Product / Process Change Notification (PCN)

PCN #: PCN_IndSI_20201211

Affected Series: WE-SI; 744xxx

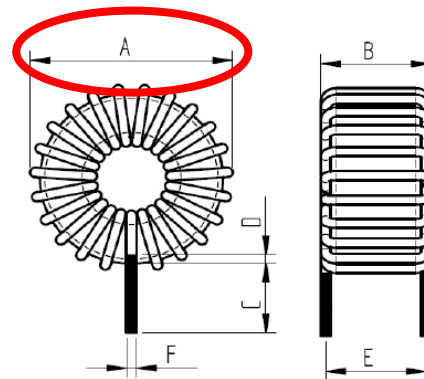
Because of a database mismatch, Würth Elektronik will correct the mechanical dimensions of the parts specified in "Detail of change".

Part Number	Length before Change [A] max.	Length after Change [A] max.
744138	43 mm	42 mm

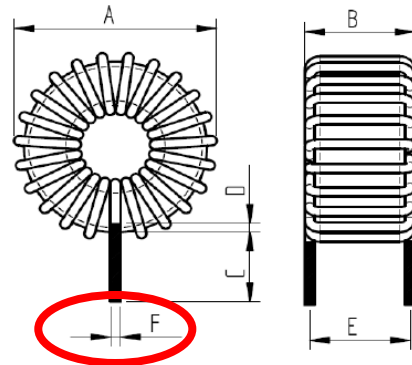
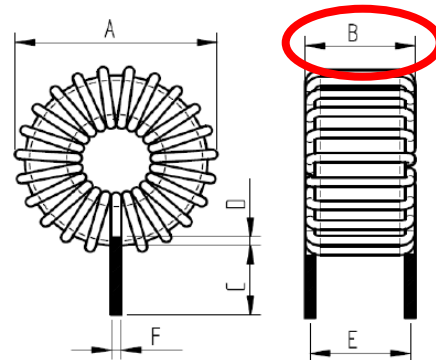
Part Number	Width before Change [B] max.	Width after Change [B] max.
744101	8 mm	8.4 mm
744105	8 mm	8.4 mm
744106	8 mm	8.4 mm
744107	12 mm	12.4 mm
744114	9 mm	9.6 mm
744115	9 mm	9.7 mm
744116	9 mm	10.1 mm
744117	12.5 mm	13.5 mm
744132	9.5 mm	10.9 mm
744133	13 mm	13.9 mm
744136	15 mm	15.3 mm
744137	15 mm	15.3 mm
744151	12 mm	12.1 mm
744152	12 mm	12.1 mm
744153	15.5 mm	15.6 mm
744155	15 mm	15.7 mm
744156	15.5 mm	16.1 mm

Part Number	Pin Diameter before Change [F]	Pin Diameter after Change [F]
744107	0.3 mm	0.32 mm
